Product Change Notification

PCN #: 6C-2022

DATE: 13th June 2022

- 453-00045

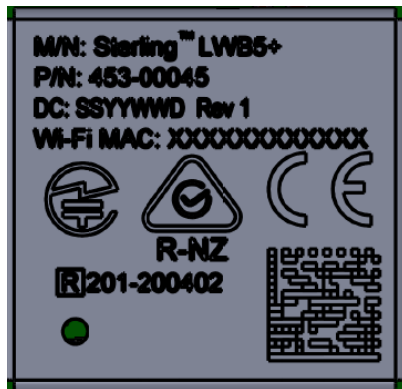
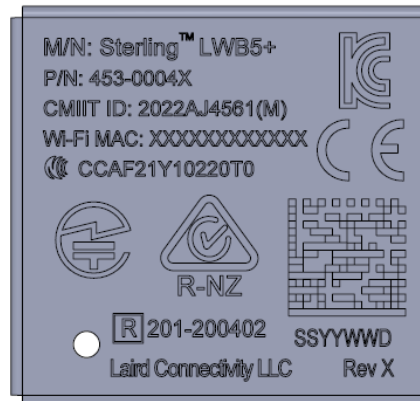
Part No.	Rev	Description
453-00045C/R	1	Certified with China SSRC, Taiwan NCC and Korea certificates
453-00045C/R 453-00046C/R 453-00047C/R	1	Certified with Korea KC certificate
453-00048 453-00049	1	Add KC ID/logo on 453-00047 RF shield

- Laser etching content change to include the certified regulatory logos and IDs
